U.S. ENVIRONMENTAL PROTECTION AGENCY, REGION 2

Re: Re: Lower Passaic River Study Draft Feasibility Study (FS) – Administrative Settlement Agreement and Order on Consent for Remedial Investigation/Feasibility Study (Agreement) CERCLA Docket No. 02-2007-2009

The U.S. Environmental Protection Agency (EPA) has reviewed *the Draft Upper 9-Mile Source Control Interim Remedy Feasibility Study (FS)* dated August 12, 2019, prepared by Integral Consulting Inc. on behalf of the Cooperating Parties Group (CPG) for the Lower Passaic River Study Area (LPRSA). Comments from partner agency, New Jersey Department of Environmental Protection and National Oceanic and Atmospheric Association were incorporated into the comments below. In accordance with Section X, Paragraph 44(d) of the Agreement, EPA has enclosed an evaluation of CPG's *Draft FS* with this letter.

Draft Upper 9-Mile Source Control Interim Remedy Feasibility Study dated August 12, 2019

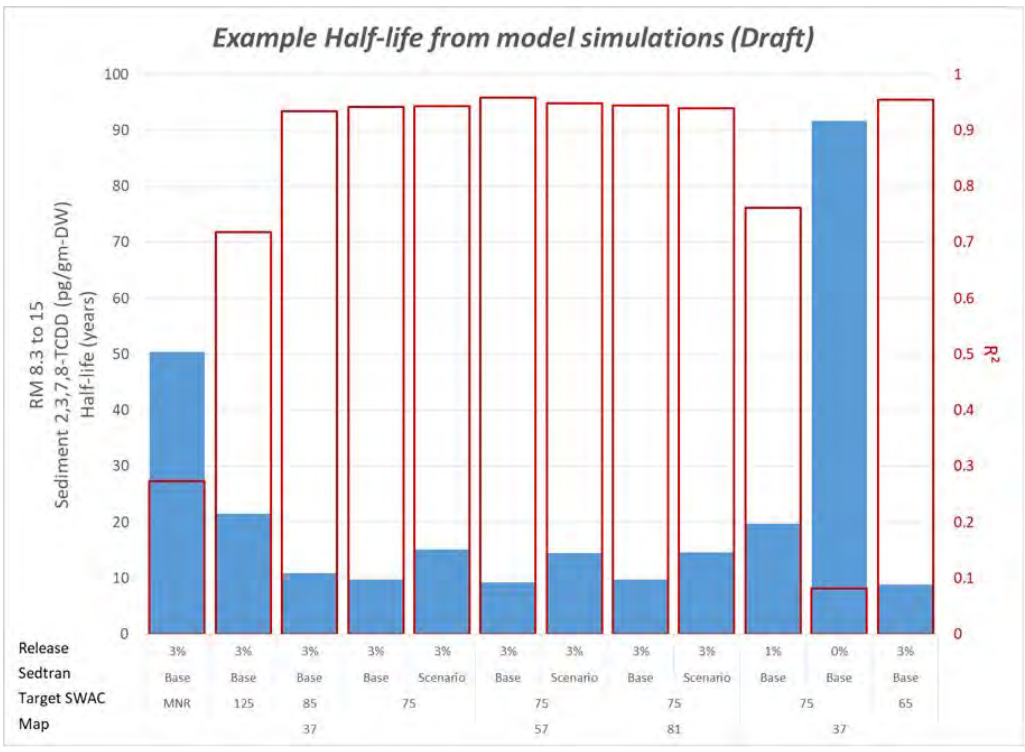
No.	Section	General or Specific	Page No.	Comment
222.	8.1.4.1	Specific	8-3 to 8-4	For Overall Protection of Human Health and the Environment, describe what determines that an alternative achieves the “ability to progress towards overall protection”. Since Protection of Human Health and the Environment is a threshold criterion, there is essentially no relative degree of compliance, rather only compliance or non-compliance. Provide additional information regarding “ability to progress towards overall protection” and what constitutes affirmation that this metric is attained.

223.	8.1.4.2	Specific	8-4	Provide expected time projections for Figures 8-1a-d and Fig 8-2a-d, as well as 8-3 and 8-4. Also, identify map CS#37 as base map used, if applicable. Finally, for Figures 8-1a-d, if feasible, identify the approximate area and sediment volume comprising the different contaminant categories depicted/estimated under pre-remedial conditions, and add this information to the legend (or reference the appropriate table for same in legend).
